CITY PLAN COMMISSION STAFF REPORT

CD-CPC-2025-00075

Linwood & Troost MPD Residential

August 20, 2025

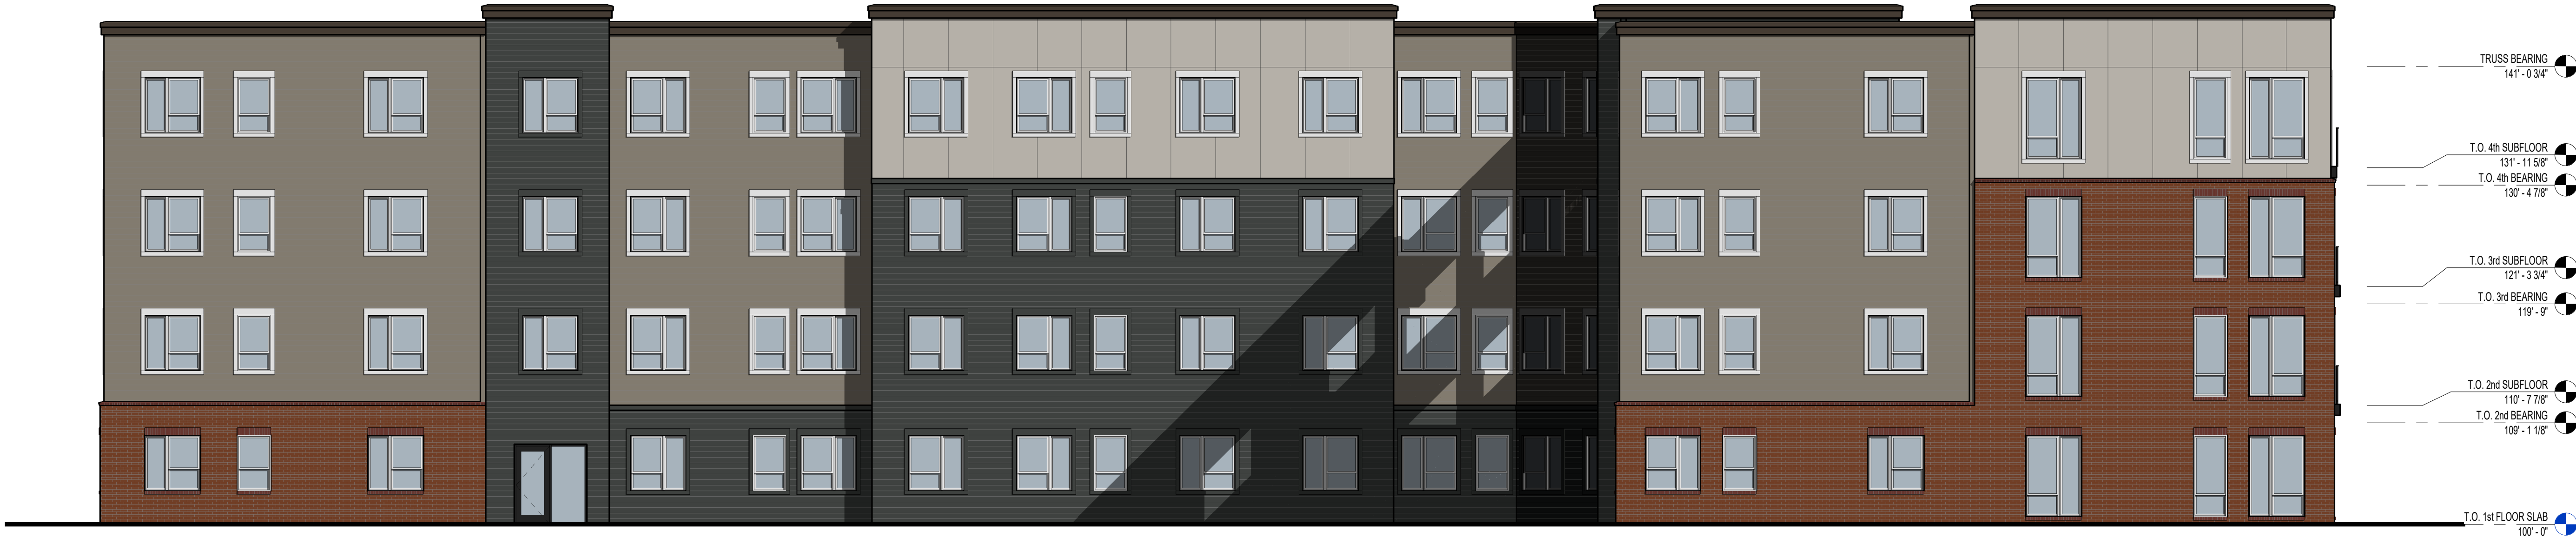
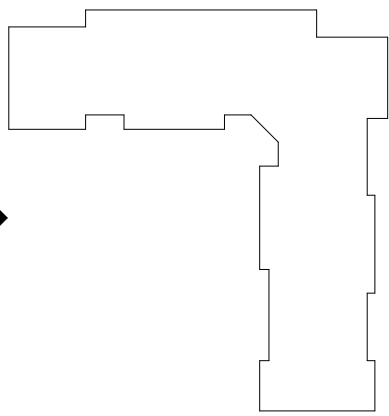
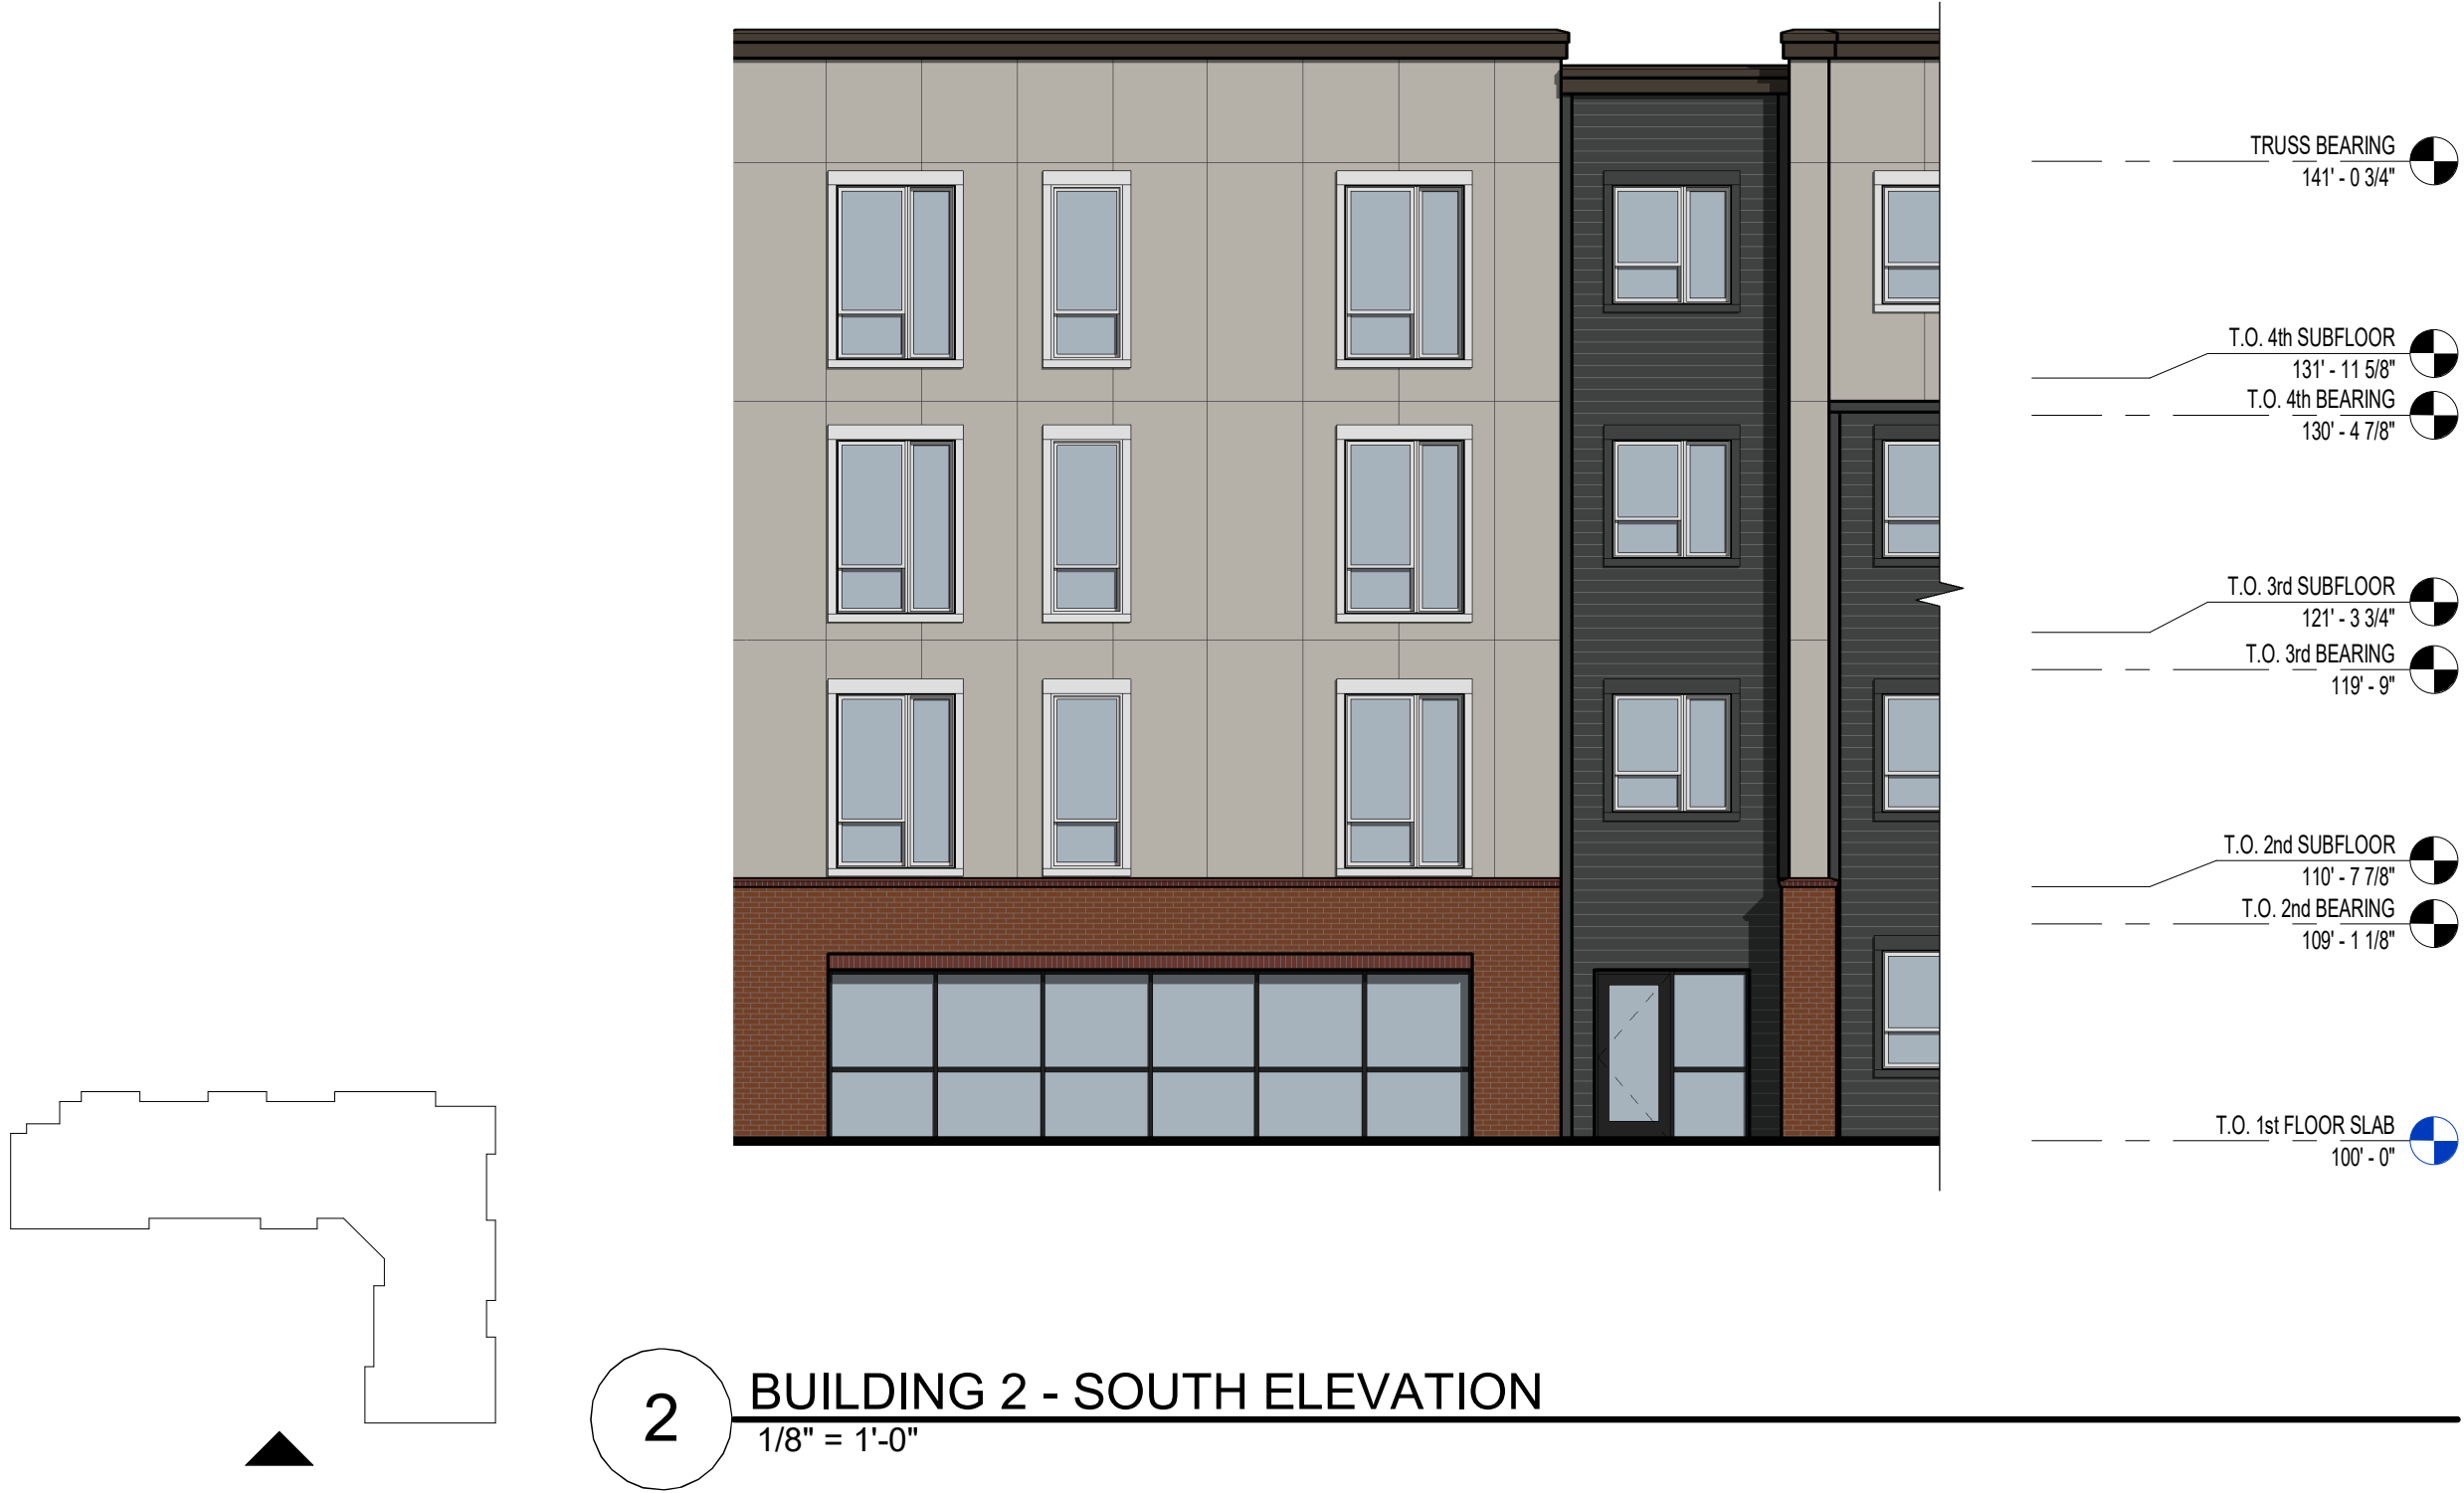
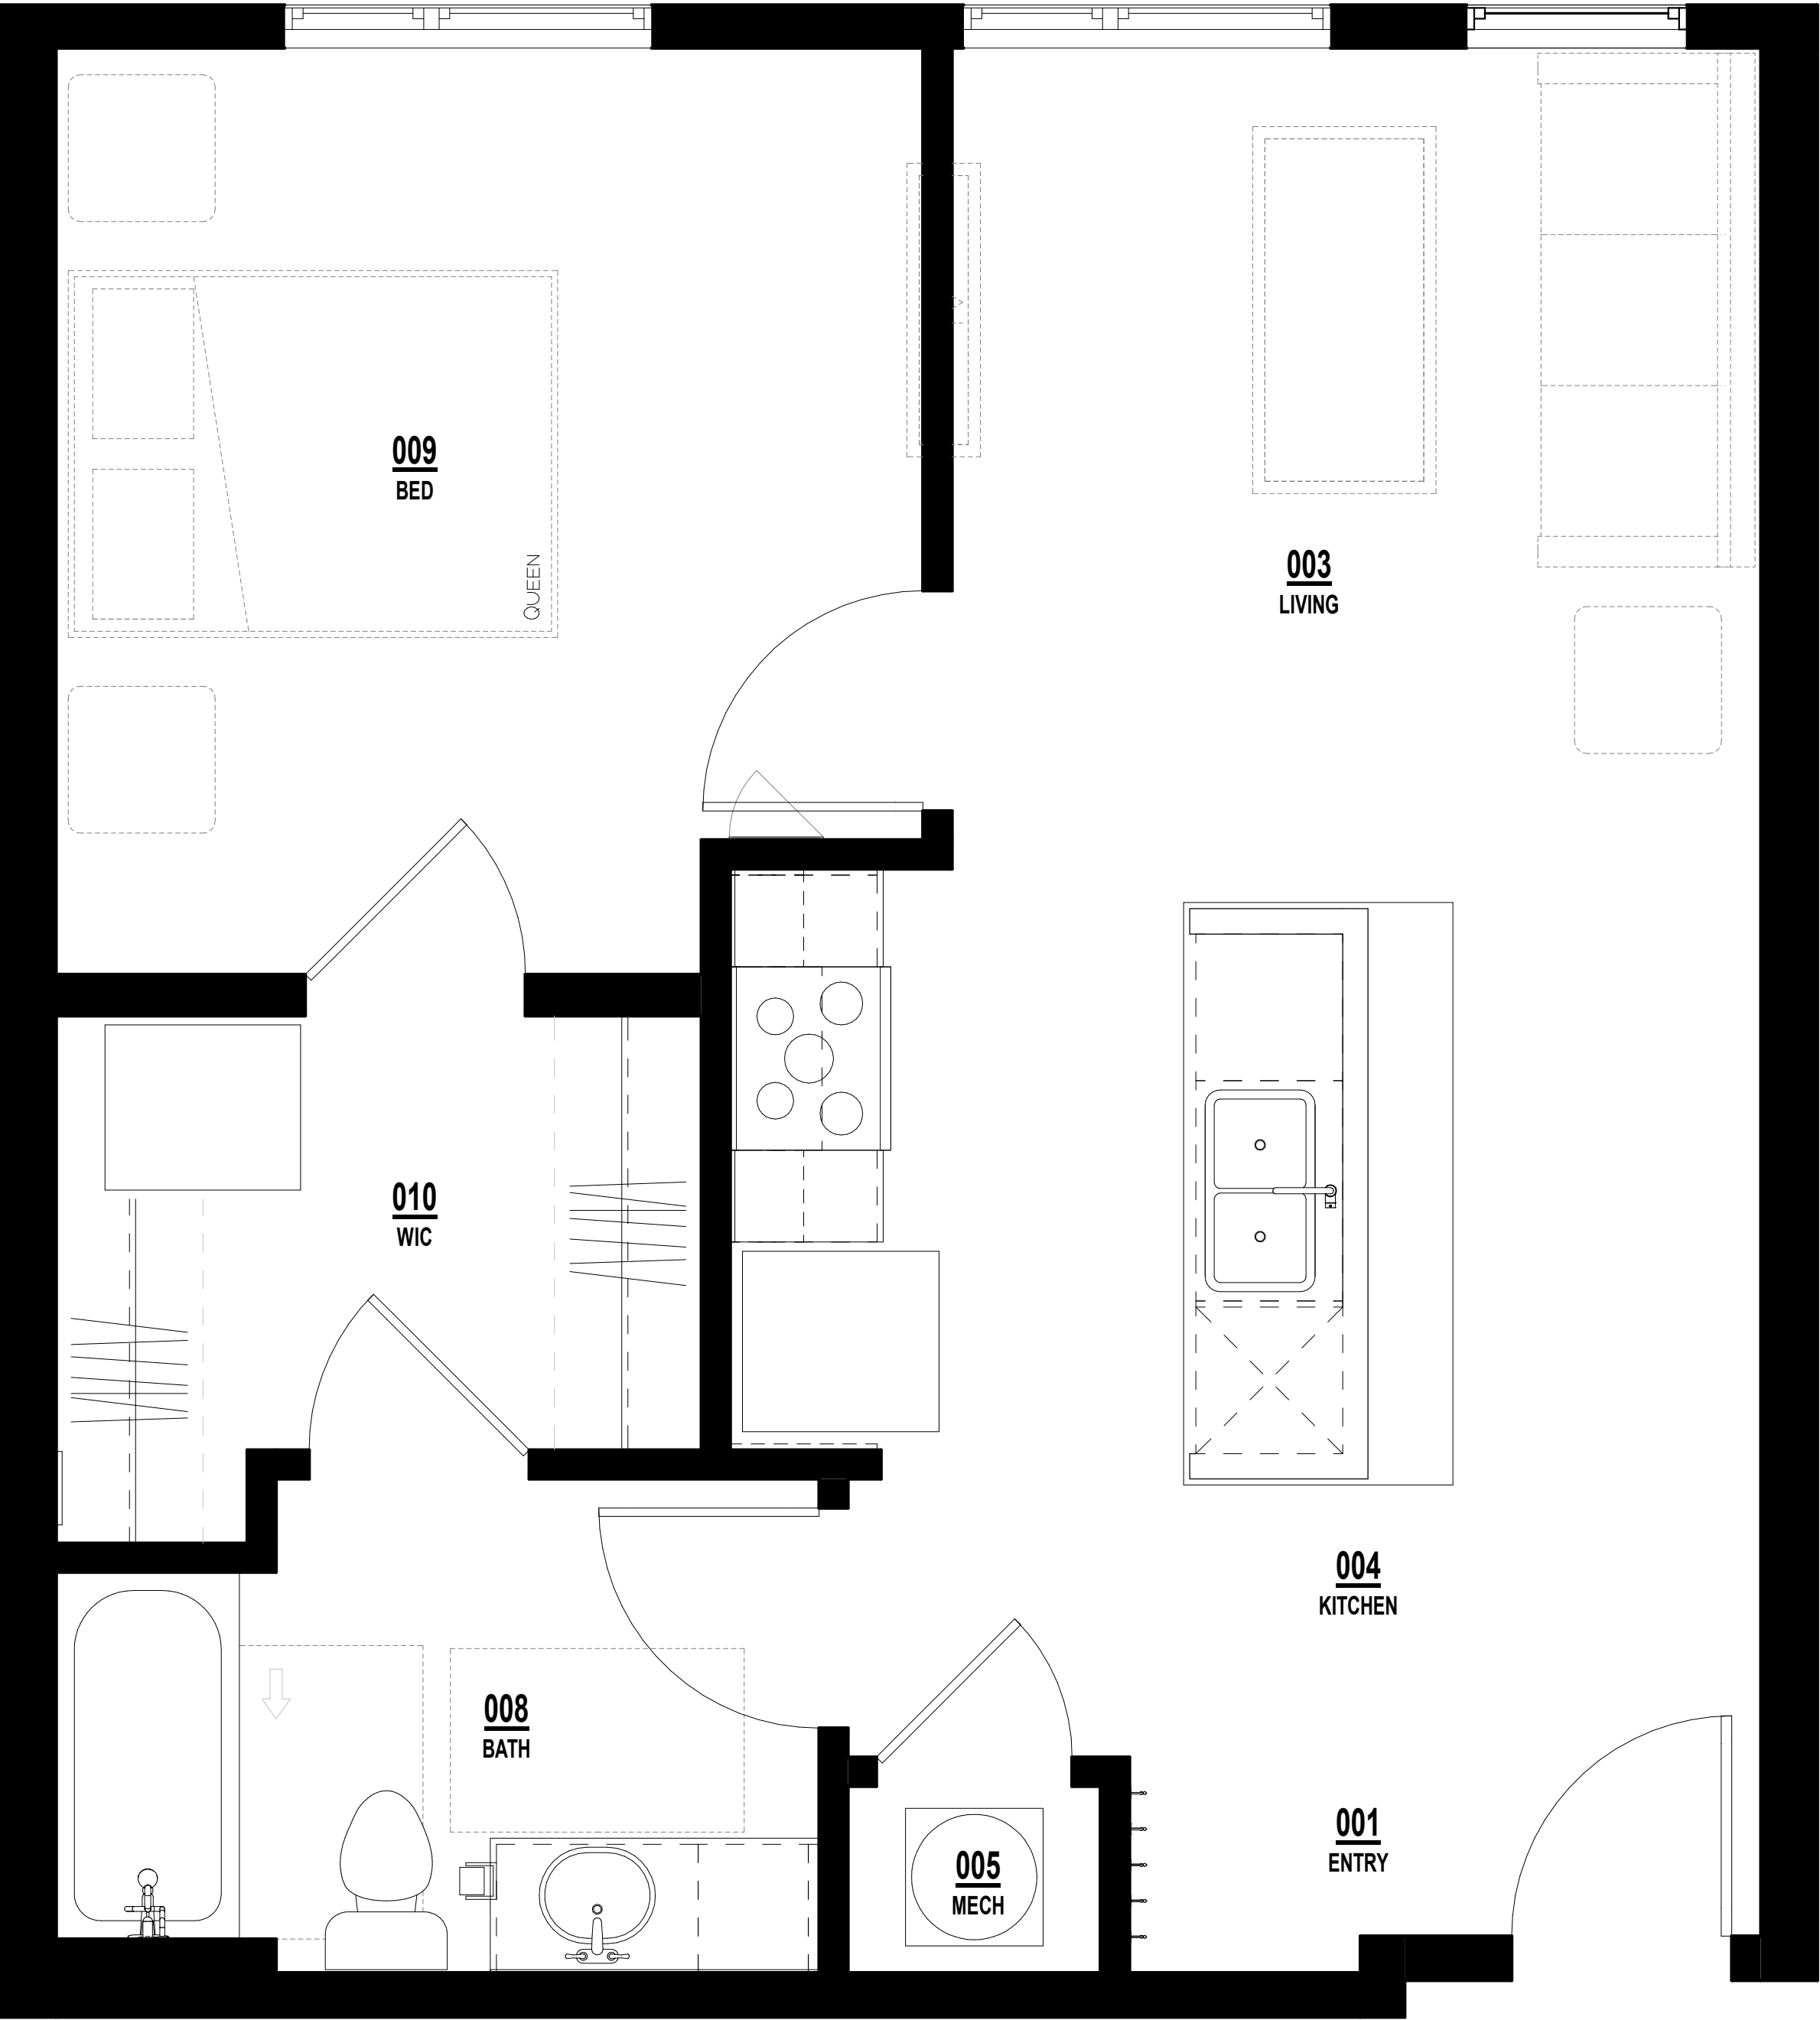
10. “Per the Troost Corridor Overlay District, at least 70% of the façade facing Troost between 3 ft and 10 ft above the sidewalk must be comprised of windows that allow clear views of indoor space. The minimum transparency standard of non-Troost facing facades is 40%. Detail compliance on the elevations. (6/13/2025)”

11. “The minimum transparency for the second story and above is 40%. Detail compliance on the elevations. (6/13/2025)”

Milhaus is happy to provide revised plans showing increased facade transparency on prominent corners and along the Troost frontage and showing compliance with the Boulevard & Parkway standards along Linwood Blvd regarding window glazing. Per recent conversations with staff, we feel our increased transparency and large window placements are much desired. We feel these improvements meet the intention of the Troost Corridor in providing an engaged street-level experience for residents and pedestrians alike.

The Milhaus team has revised the elevations previously provided to include additional brick on prominent corners along Troost Ave and along street-facing facades. We have also swapped out much of the lap siding for paneling in order to provide for a more modern and quality design.

Milhaus is happy to provide revised plans showing increased facade transparency on prominent corners and along the Troost frontage and showing compliance with the Boulevard & Parkway standards along Linwood Blvd regarding window glazing. Per recent conversations with staff, we feel our increased transparency and large window placements are much desired. We feel these improvements meet the intention of the Troost Corridor in providing an engaged street-level experience for residents and pedestrians alike.
